Subject: Rezoning Application for Lot 14, Plan 269 - 116 Lucas Street, Richmond Hill, Ontario - Town File No. D02-18010 (Related File D06-18020) (SRPRS.19.008)

**Subject: Rezoning Application for Lot 14, Plan 269 - 116 Lucas Street, Richmond Hill, Ontario - Town File No. D02-18010 (Related File D06-18020) (SRPRS.19.008)**

**RE: Rezoning Application for 116 Lucas St., Town File #D02 – 18010**

**Figure 1 Girdling on Tree No. 1066**

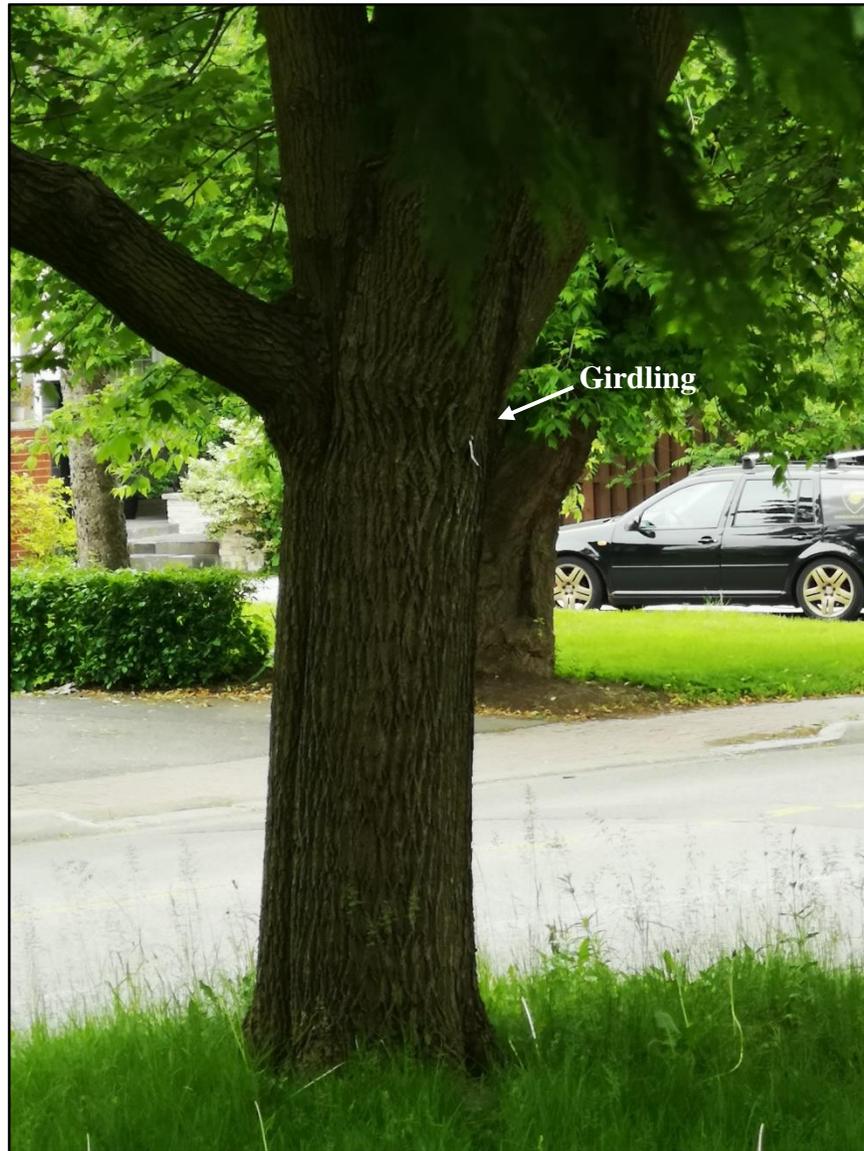
Based on my June 14<sup>th</sup>, 2019, review of the Arborist Report made available at the Planning Counter of the Town's Municipal Offices (4<sup>th</sup> floor, 225 East Beaver Creek Road), I understand that the Applicant proposes to remove Tree No. 1066, a Town-owned Norway Maple tree, to facilitate the construction of two semi-detached dwellings at 116 Lucas Street. It is noted that Tree No. 1066 was described within the Arborist Report as having "... *girdling on the West side of the tree...*" and "... *decay from an old pruning wound on the East side of the crown, ...*", and as having "... *imbalanced growth...*" and "... *poor growth rates...*"

I submit to the Town that the girdling on the West side of Tree No. 1066 is an old injury to the tree and that the tree has fully and long since healed from such injury. As such, the past girdling injury to the tree does not in any manner affect the general health of Tree No. 1066. I also submit to the Town that the old pruning wound to and imbalanced growth of Tree No. 1066, is a consequence of the Town's neglect of the tree. Last, I submit that Tree No. 1066 is in general good health and that the tree can be pruned to restore balanced growth. An image of the girdling injury to Tree No. 1066, as noted within the Arborist Report, is provided in Figure 1 of this letter.

Last, I ask that Town-owned Tree No. 1066 not be removed and that it be preserved to maintain the overall character of Lucas Street. I also ask that further consideration be given to the impacts on the TPZ of Tree No. 1064, 1065, 1082, 1083, 1084, 1085 and 1086, prior to Council granting approval of the proposed development at 116 Lucas Street.

**Figure 2 Shadow Impacts to 120, 120A Lucas Street, Summer Solstice**

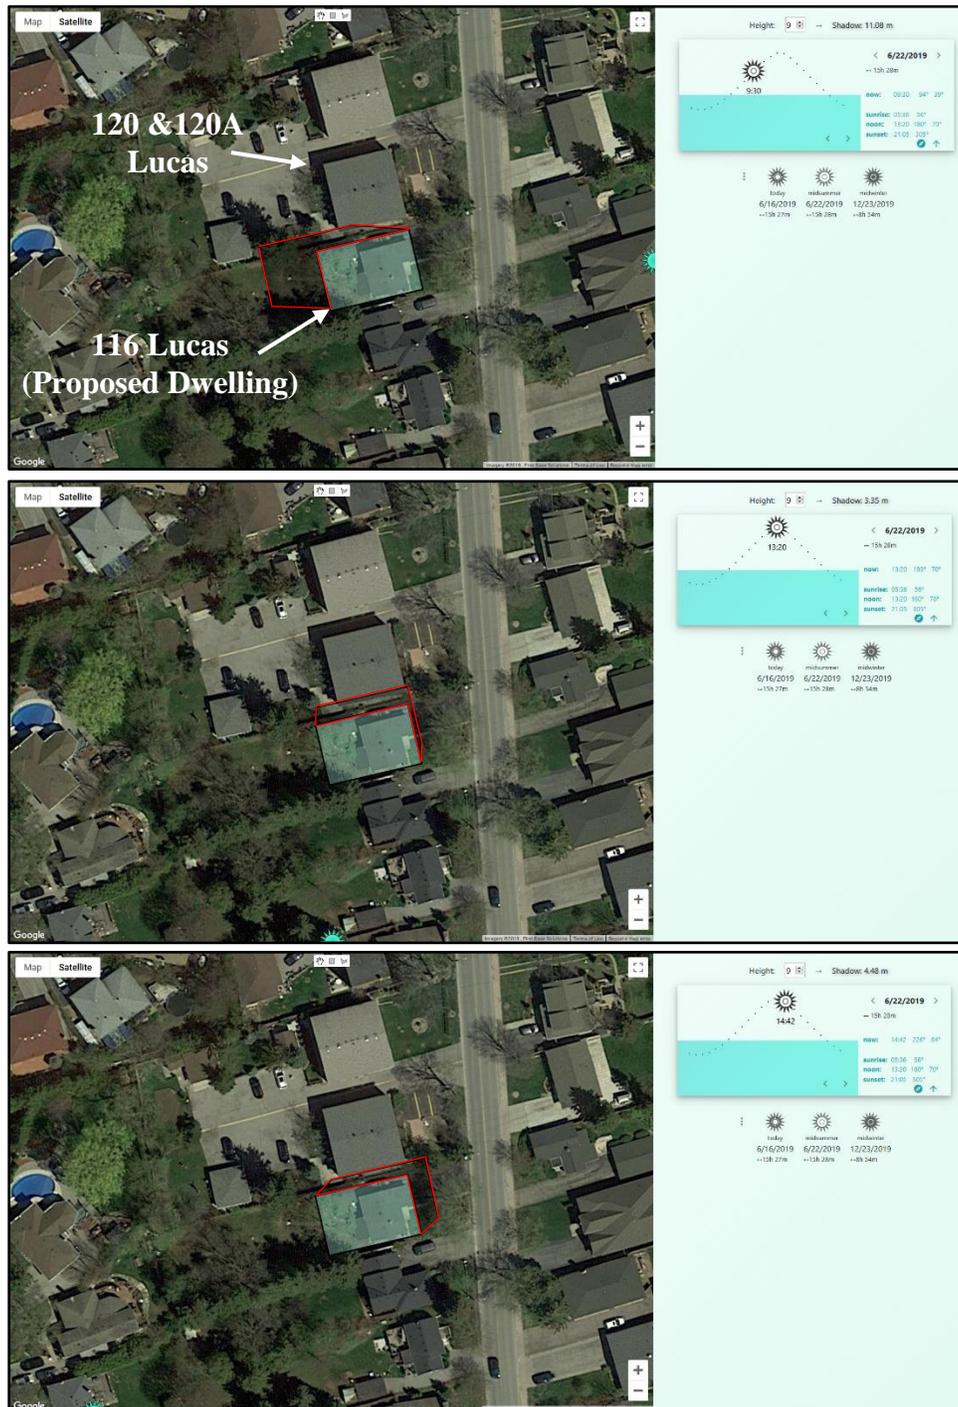
Having no evidence that there would be no Shadow Impacts to the lands immediately North of and adjacent to 116 Lucas Street, I conducted a preliminary evaluation of the Shadow Impacts of the proposed development, as based on the proposed dwelling height and MIYS. Given that the South faces of 120 and 120A Lucas Street serve as the dwellings’ main and only entrances and that both dwellings only have two faces with windows, I have found that the Shadow Impacts to 120 and 120A Lucas Street by the proposed development would be extensive and adverse.

The proposed structure(s) would, in fact, create extensive cast shadow onto 120 and 120A Lucas Street, during most hours of most days of the year, and would substantially reduce sunlight and daylight exposure at 120 and 120A Lucas Street. The Shadow Impacts from the proposed dwellings at 116 Lucas Street and onto 120 and 120A Lucas Street are illustrated in the images of Figures 2 to 4 of this letter, as they would occur during fall and spring equinoxes and during winter and summer solstices.

As such, and contrary to the Town Staff report conclusions that “... *the proposed development is not expected to create any adverse shadowing impacts on adjacent lands*”, I submit that the statements offered within the Shadow Impact section of Town Staff Report No. SRPRS.19.118 are unfounded, misleading and fail to address the very real and significant Shadow Impacts that the proposed dwellings at 116 Lucas Street would create, on the lands and dwellings at 120 and 120A Lucas Street. Last, it is my opinion that Town Staff failed to perform its due diligence, by not ensuring that the Applicant provide a Shadow Impact report.

I also ask that Town Staff request that the Applicant perform and submit an official Shadow Impact study and that Town Staff carefully evaluate said study, prior to Staff recommending site-specific exceptions to the applicable standards at 116 Lucas Street. I note that my preliminary assessment of the Shadow Impacts by the proposed dwellings at 116 Lucas Street indicate that the Shadow Impacts would be significant and adverse in nature, to the residents at 120 and 120A Lucas Street.
